Horsley Drive Business Park Stage 2 - Buildings 2 & 3 (SSD-17161650)

Response to Submissions Report

12 May 2022 | 2200737

Figure 2 Office relocation

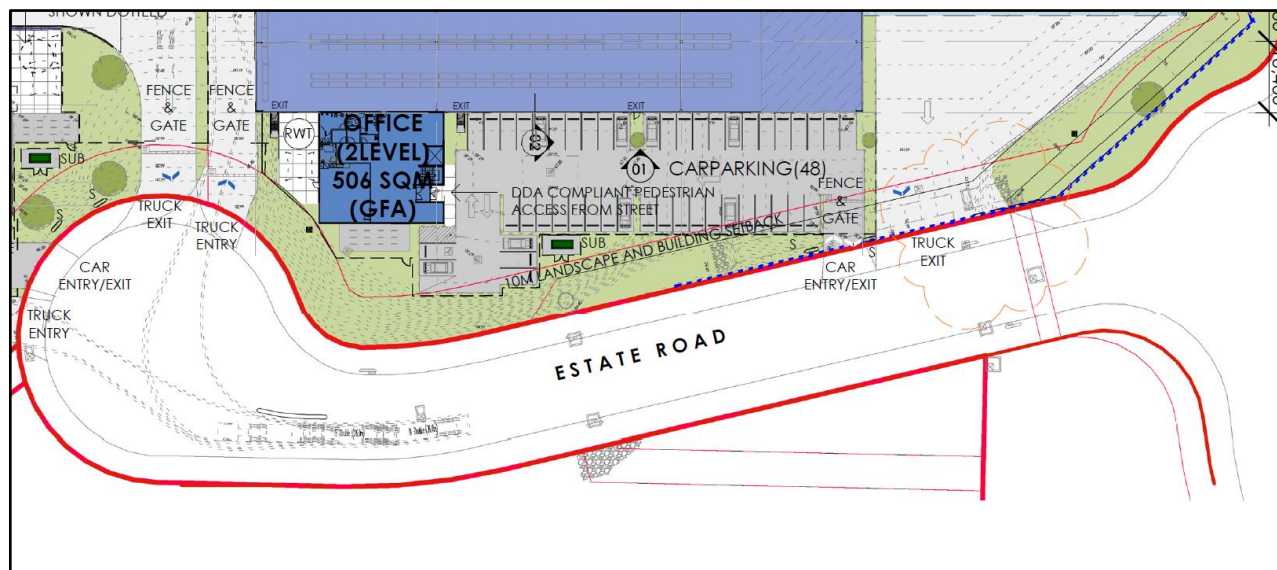
To facilitate the introduction of a new exit driveway to Warehouse 3, the proposal has been amended to relocate the Warehouse 3 Office component to the southern elevation (from its previous location at the eastern elevation).

As shown in **Figure 2** below, the Warehouse 3 Office gross floor area remains the same as that outlined within the EIS but the relocation to the southern elevation allows for improved heavy vehicle circulation for Warehouse 2.
